BAILEY ACRES CLUSTER SUBDIVISION PH.1 2nd Amendment

AMENDMENT OF LOTS 2 AND 3
PART OF THE SOUTHWEST QUARTER OF SECTION 17, T.7N., R.1E., S.L.B.&M., U.S. SURVEY
WEBER COUNTY, UTAH
JULY, 2014

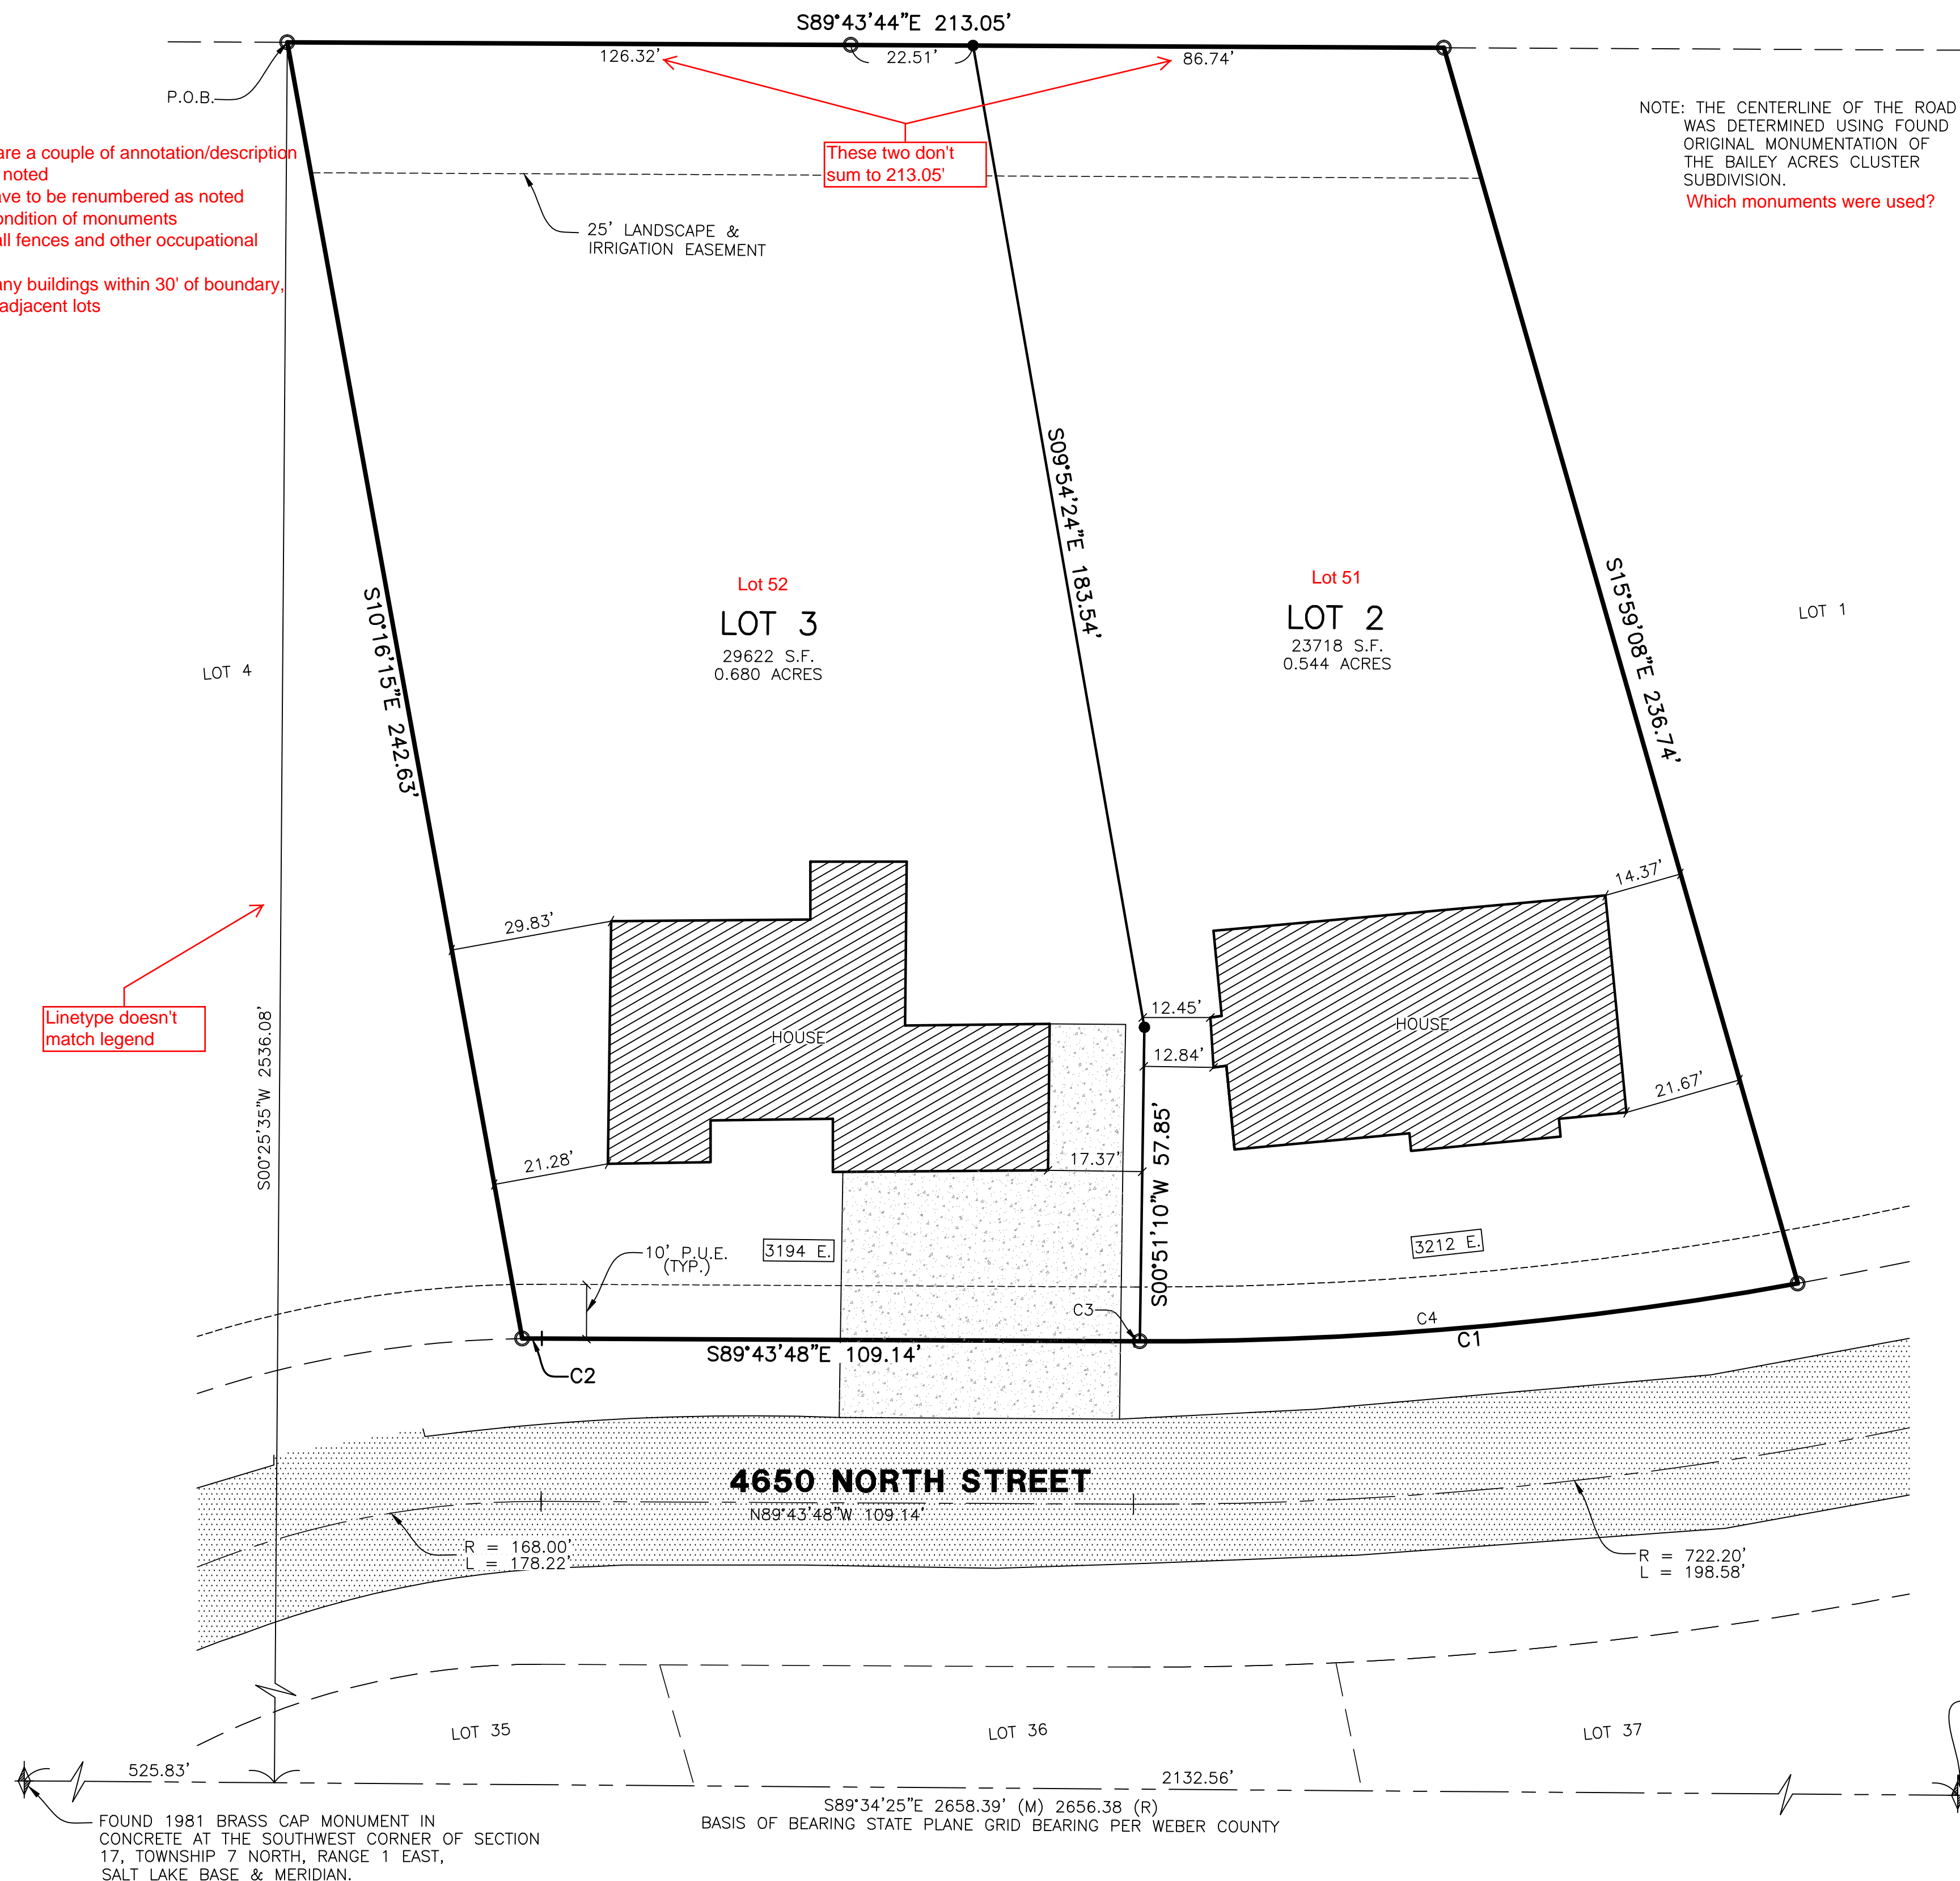
1. There are a couple of annotation/description issues as noted
2. Lots have to be renumbered as noted
3. Give condition of monuments
4. Show all fences and other occupational evidence
5. Show any buildings within 30' of boundary including adjacent lots

NOTE: THE CENTERLINE OF THE ROAD WAS DETERMINED USING FOUND ORIGINAL MONUMENTATION OF THE BAILEY ACRES CLUSTER SUBDIVISION.
Which monuments were used?

Why are they adjusting the lines?

Doesn't match curve table

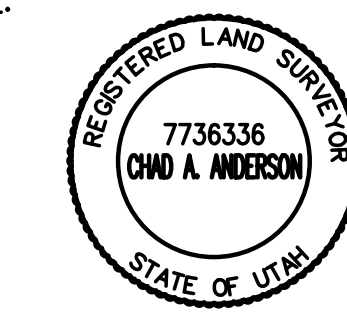
Location?
